WILLIAMSON COUNTY, TEXAS

CHANGE ORDER NUMBER: 1

Project:	<u>1803-219</u>
Roadway:	<u>SW Bypass Segment 2</u>
CSJ Number:

Southwest Bypass Segment 2 Williamson County Project No. 1803-219 Change Order No. 1

DESIGN	JC	FED. RD. DIV. NO.	6	FEDERAL AID PROJECT NO.		HIGHWAY NO.	
GRAPHICS	KB	STATE	TEXAS	DISTRICT	AUS	COUNTY	WILLIAMSON
CHECK	JW	CONTROL	SECTION	JOB			
CHECK	JC	2103	01	034			59

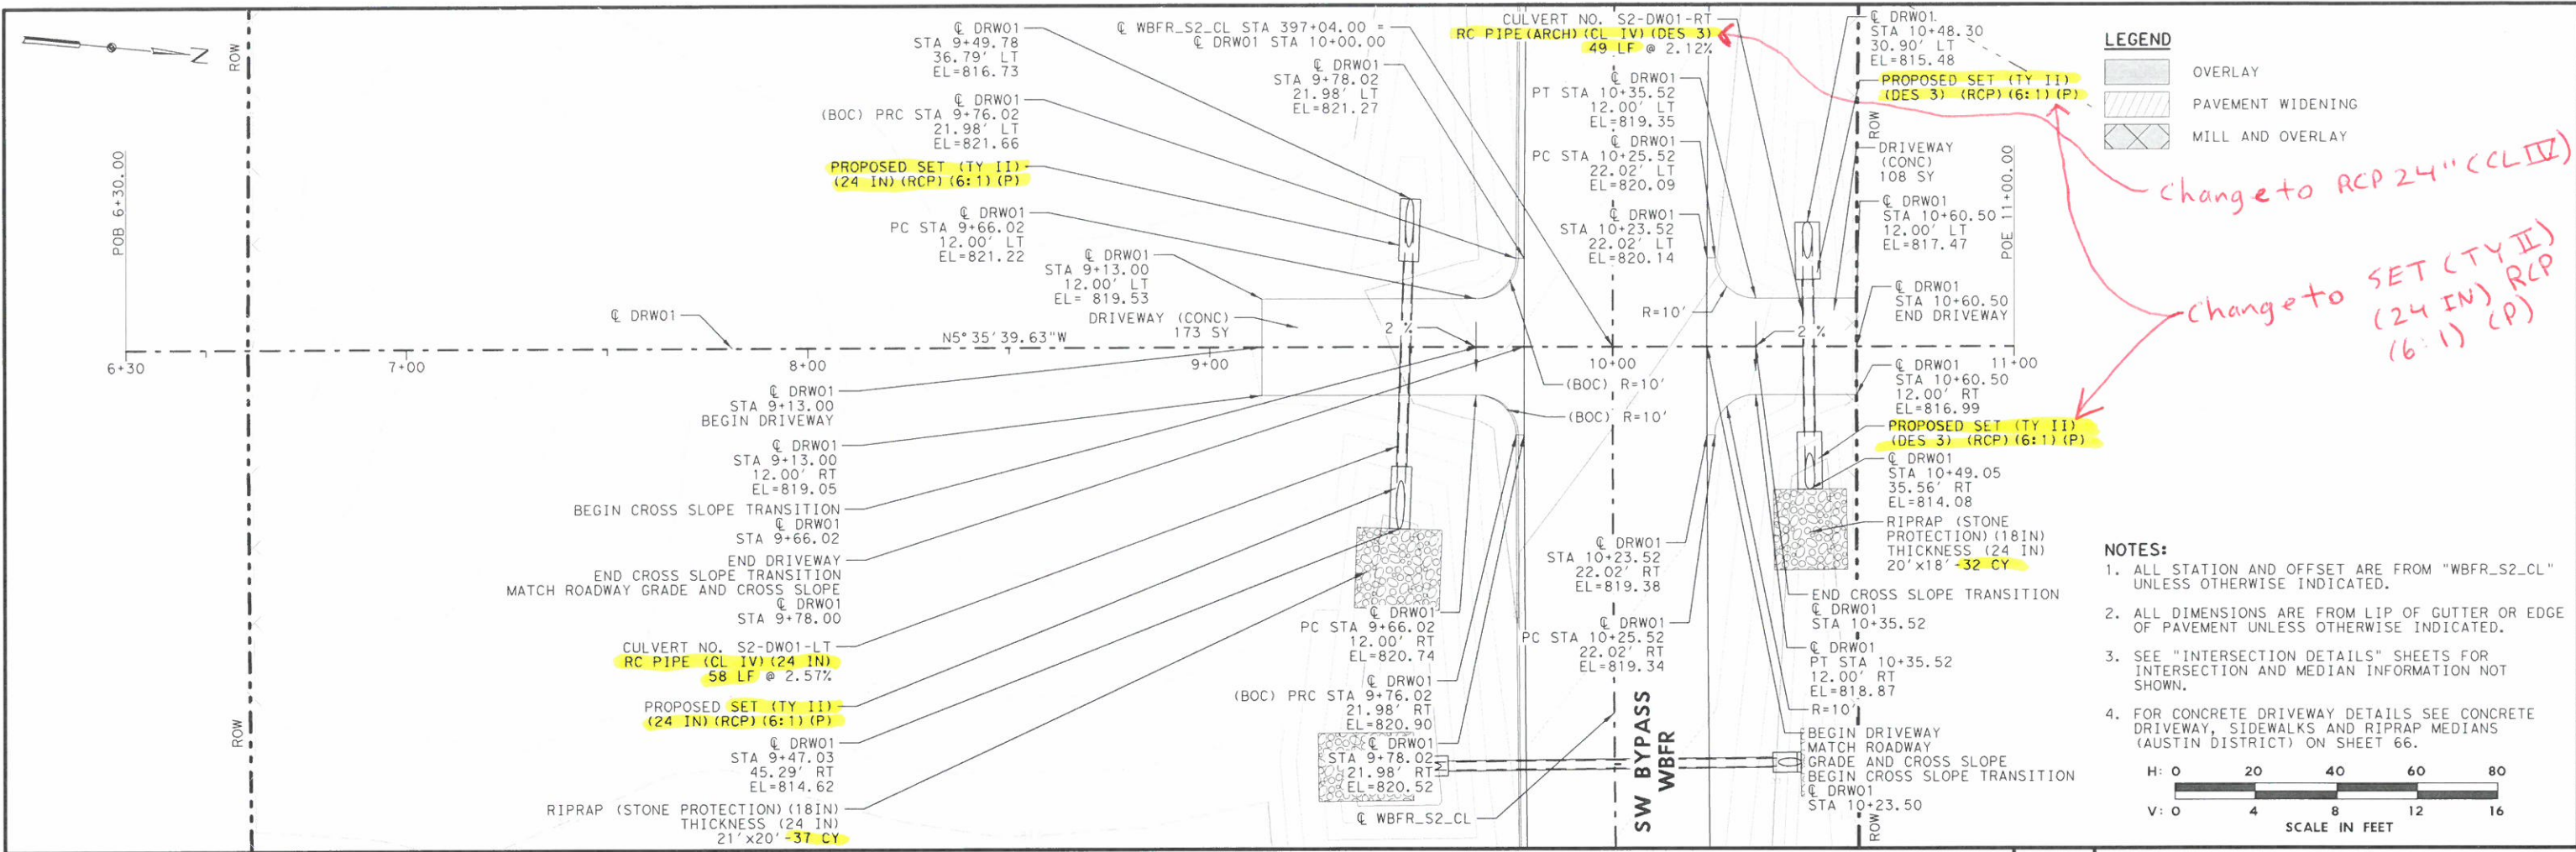
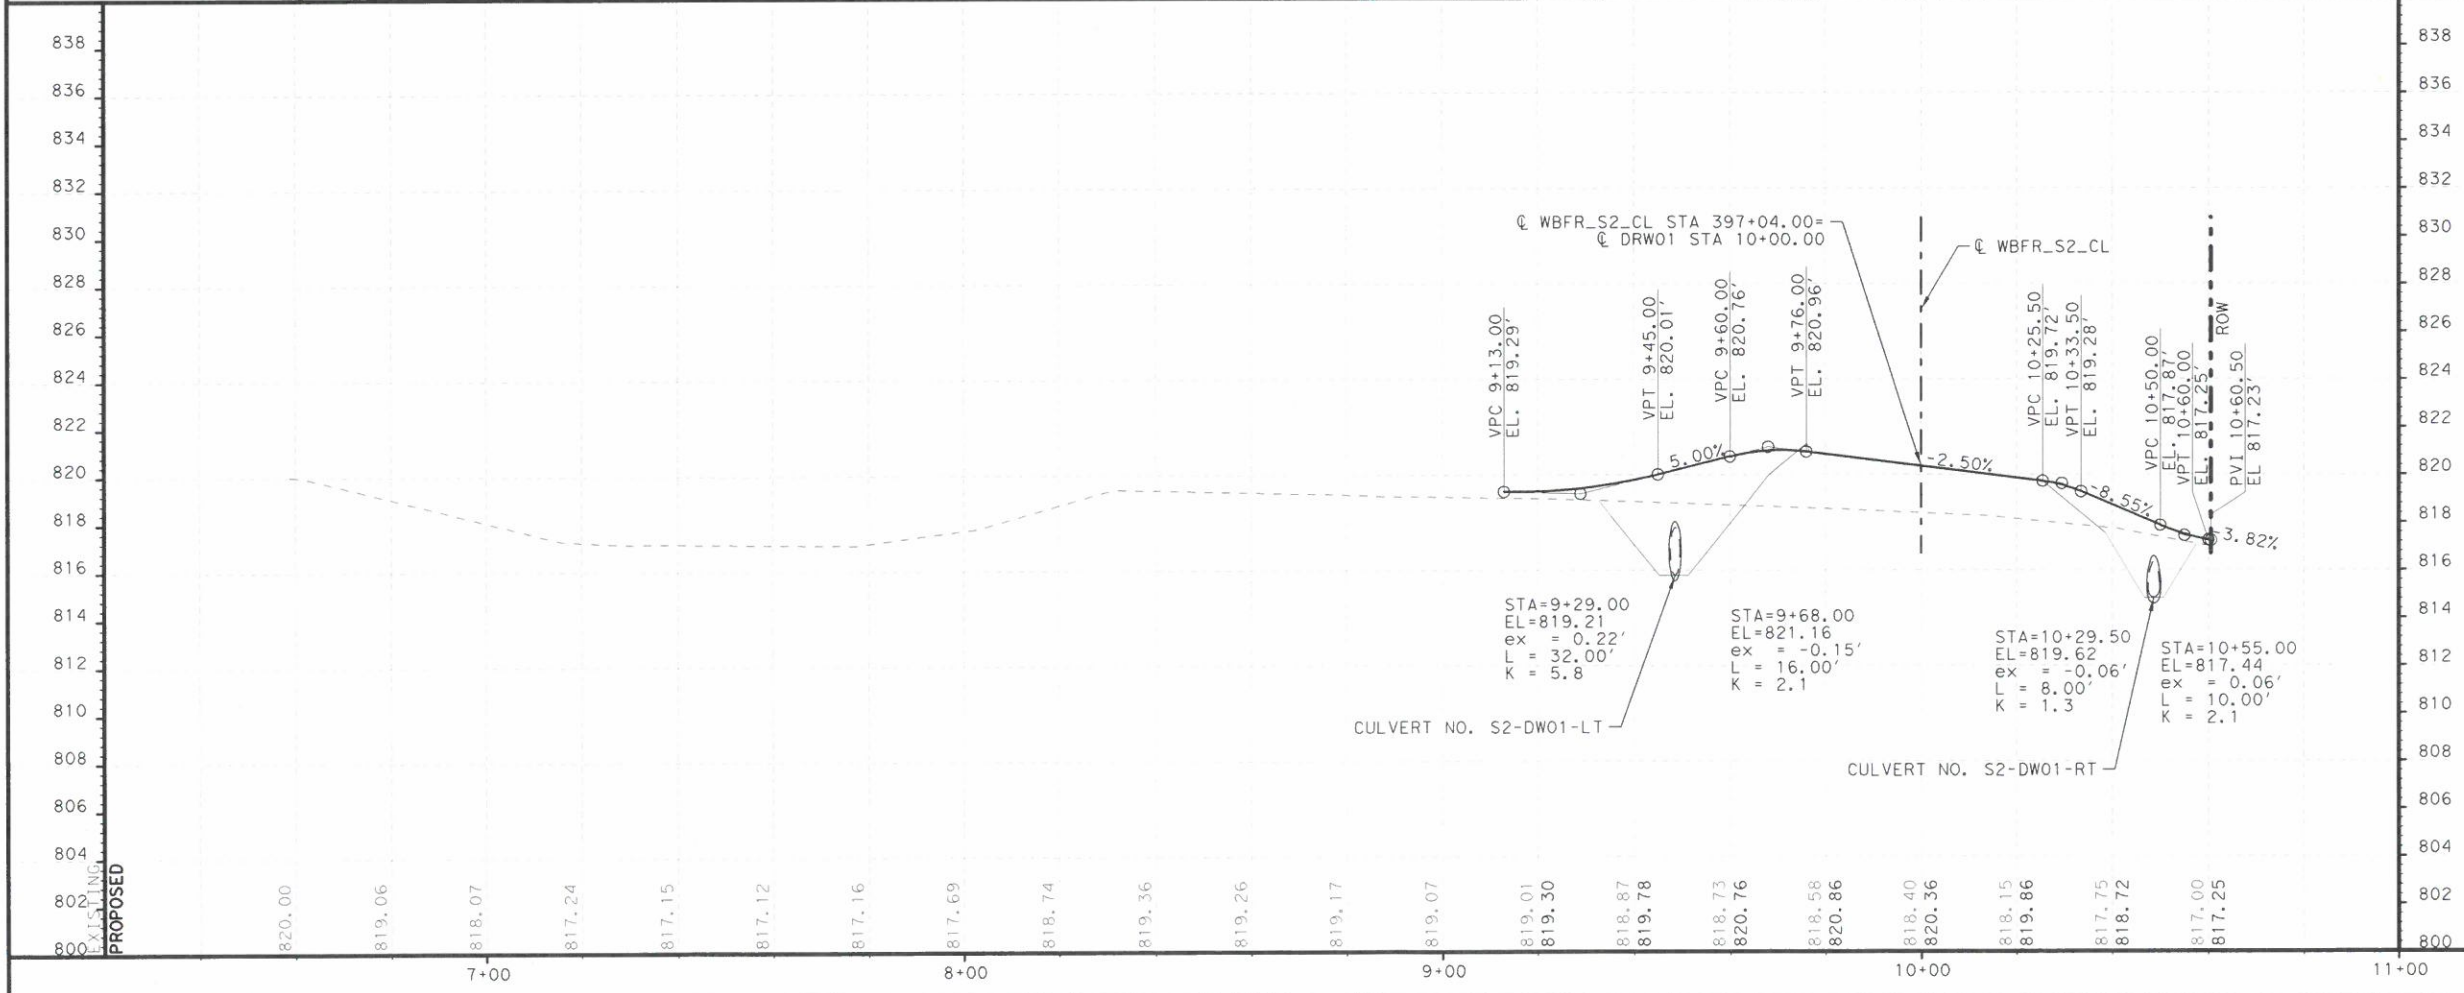
change to RCP 24" (CL IV)

change to SET (TY II) (24 IN) RCP (6:1) (P)

DESIGN	JC	FED. RD. DIV. NO.	6	FEDERAL AID PROJECT NO.		HIGHWAY NO.	
GRAPHICS	LG	STATE	TEXAS	DISTRICT	AUS	COUNTY	WILLIAMSON
CHECK	JW	CONTROL	2103	SECTION	01	JOB	034
CHECK	JC

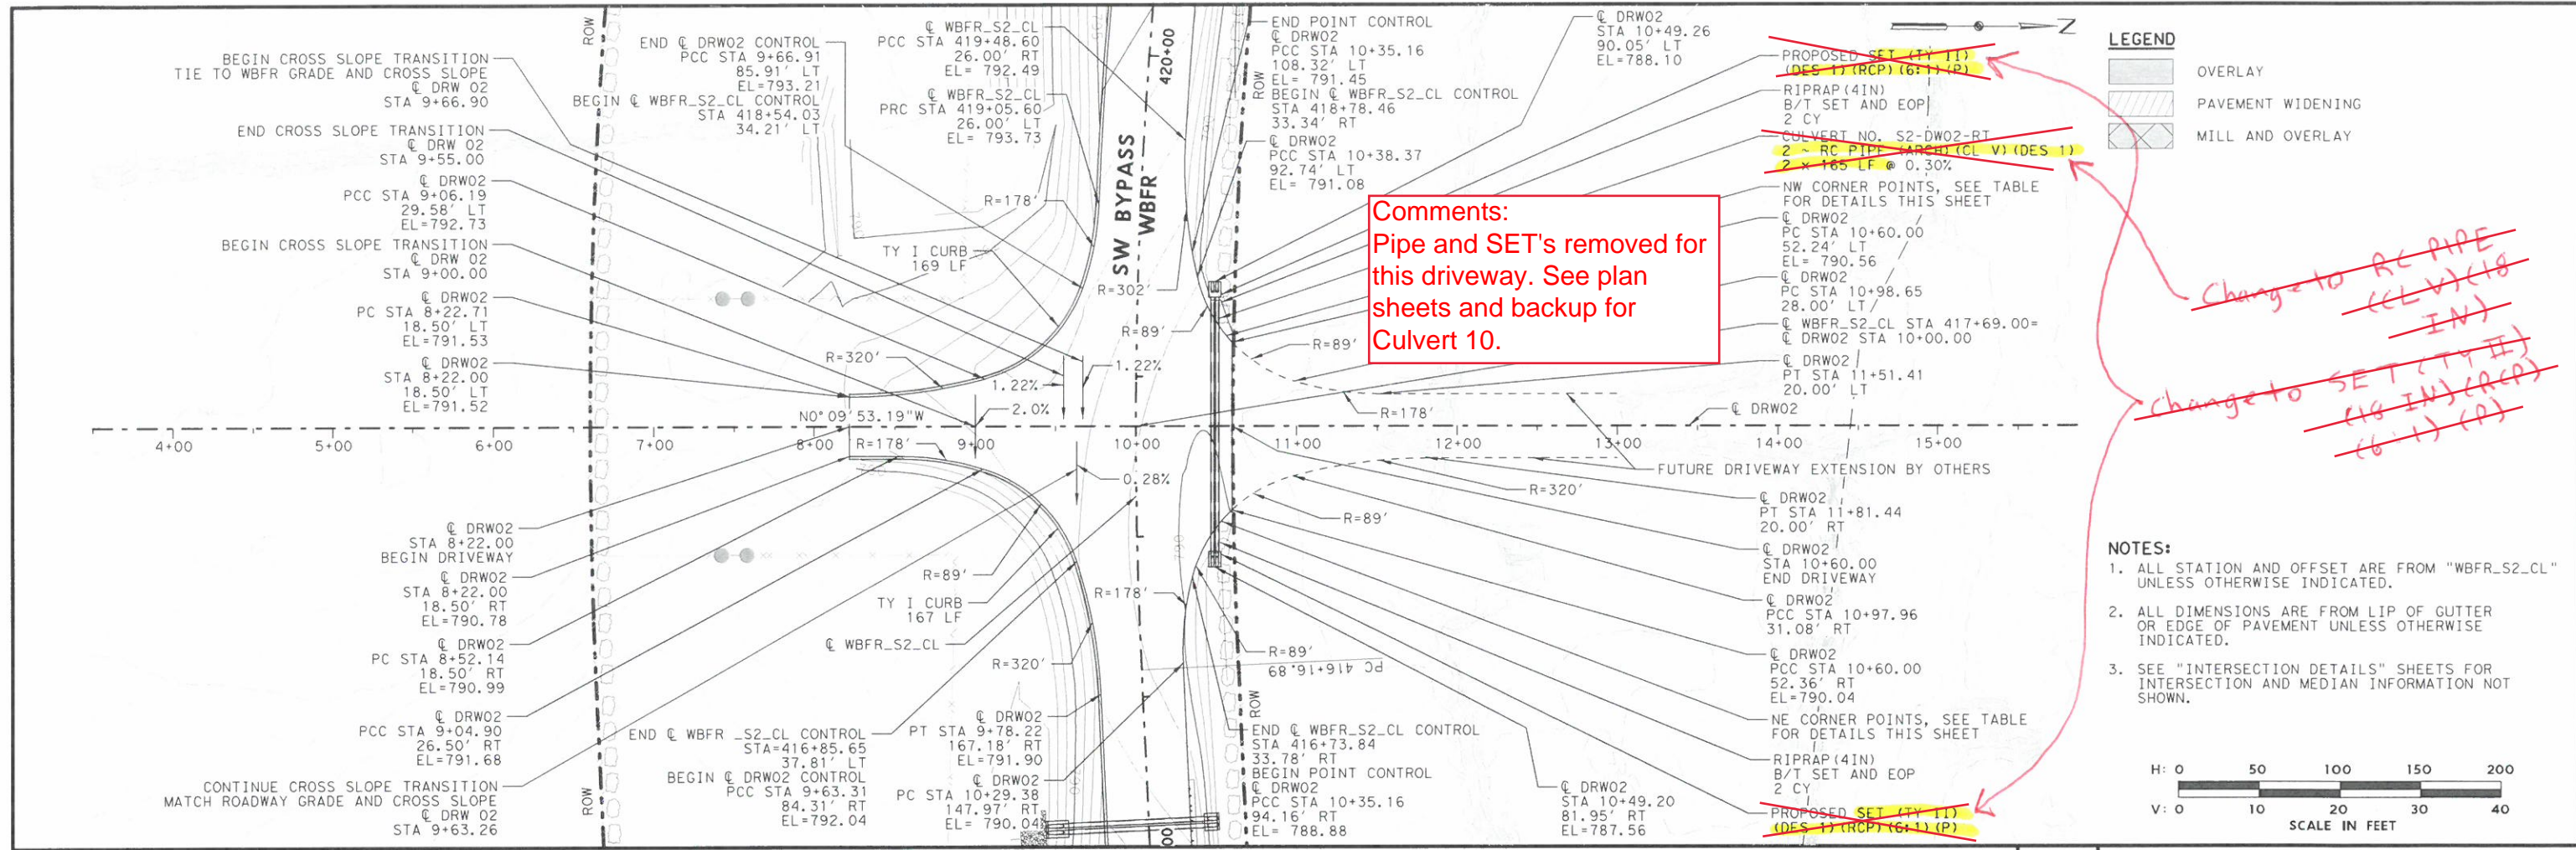
Change to RC PIPE (CL V) (18 IN)

OVER EXCAVATION DETAIL
APPROXIMATE STA 427+90.00 TO STA 432+85.00

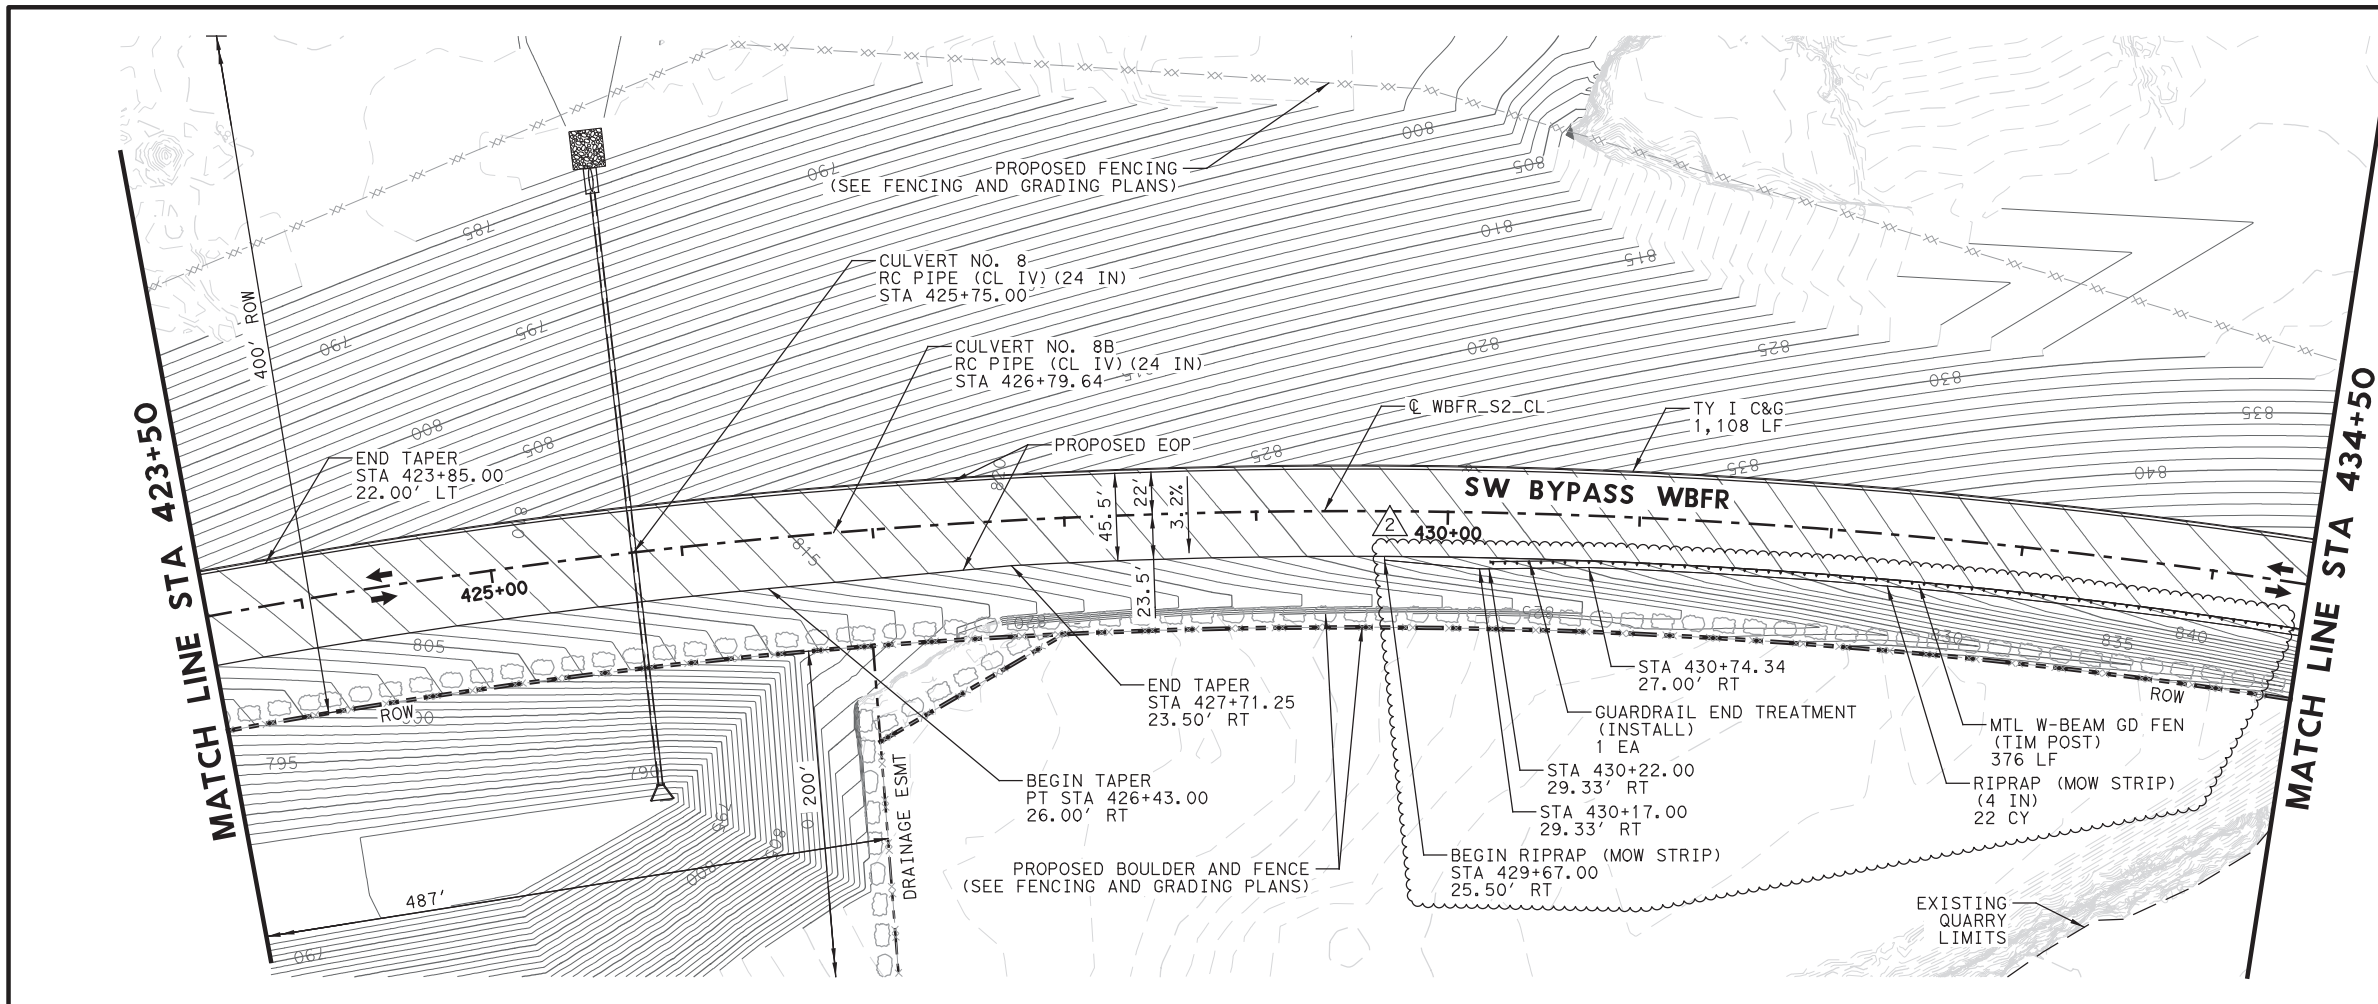
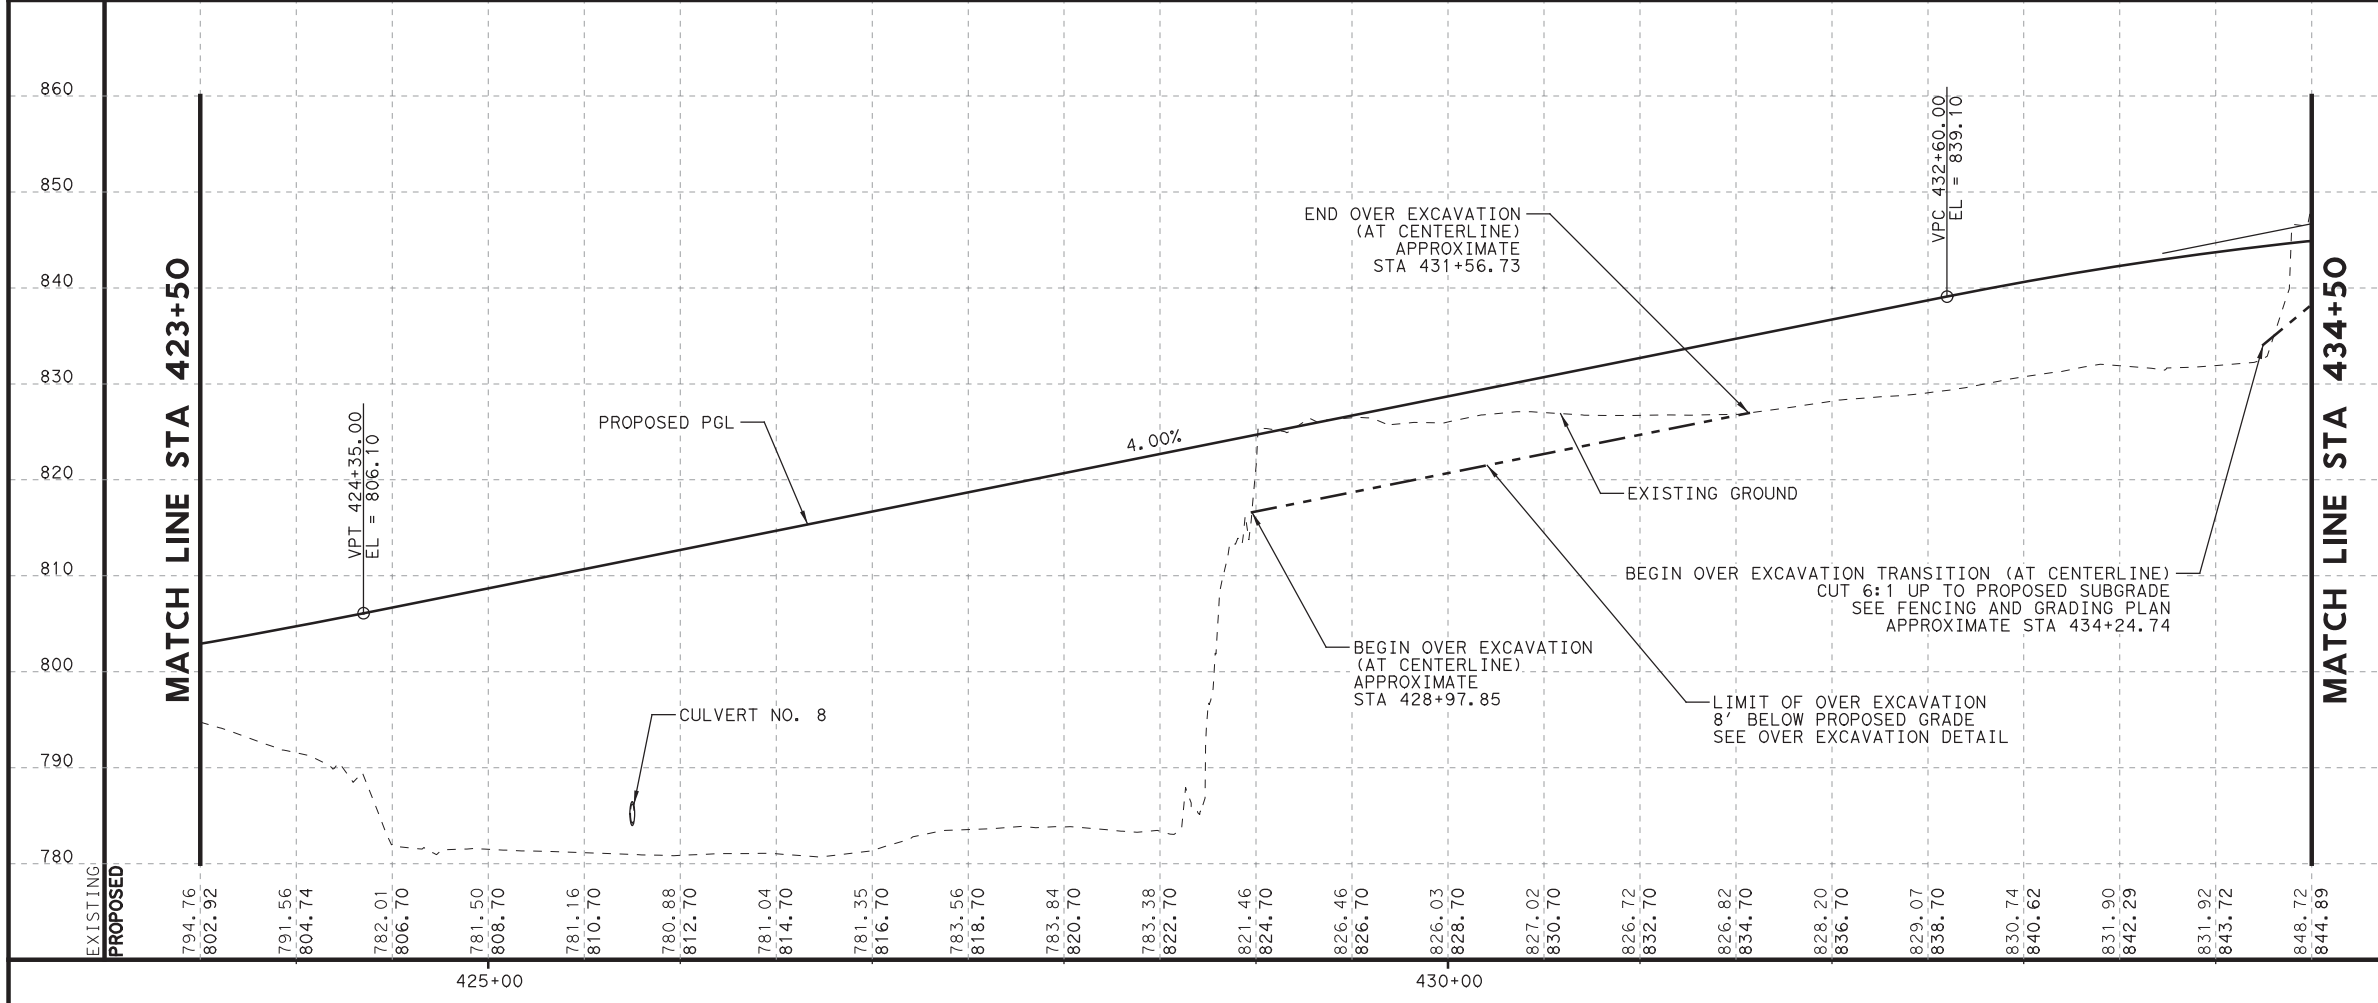
Multiply unit rates for all
new items (8) in this
Change order by 1.15,
per meeting with JCG on
2/24/2020.
ERC
